Title: North West Coast
Connections Initial Needs
Case Assessment

Client: Ofgem

Report N°: 11305-01-R2

Date: 14 December 2016

Figure 2-8 B6 Boundary Transfer Capabilities under a Range of FES and Moorside Connection Options (Source: NGET)

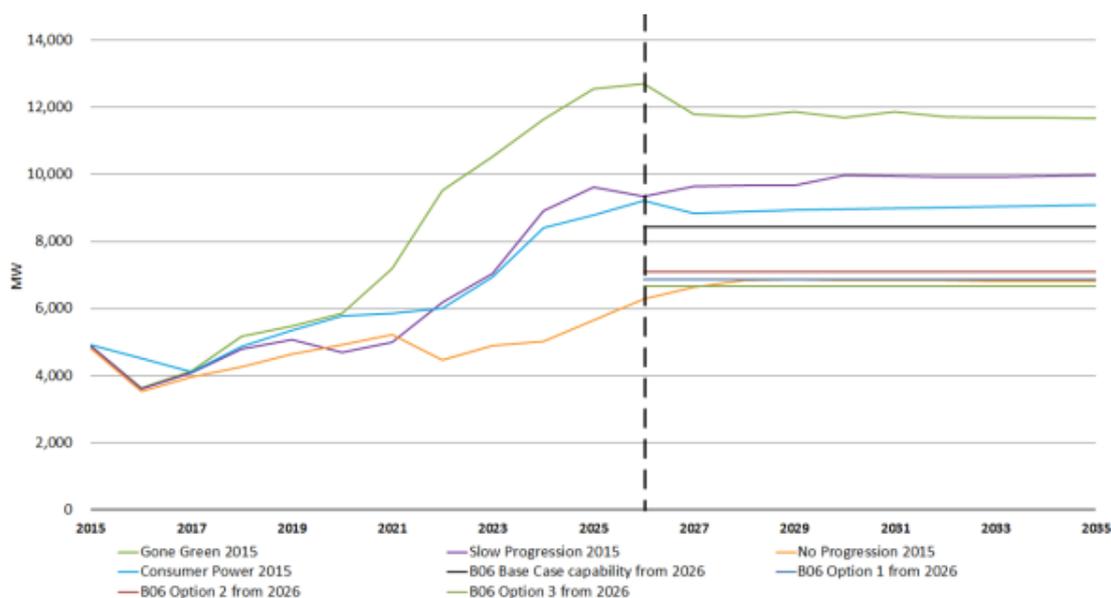
Based on our desktop assessment of the network topology and power flows in the region under NETS SQSS and the various FES, we agree with NGET that the FES will not materially influence the boundary transfer capabilities of B6, B7 and B7a under the modelled network conditions. However, we have some general concern that under different circumstances (e.g. for different projects), the choice of scenario could affect the calculated boundary capability. For example, if examining a boundary which has more than two AC circuit routes crossing it or if there is a large amount of generation adjacent to the boundary in one scenario but not another.
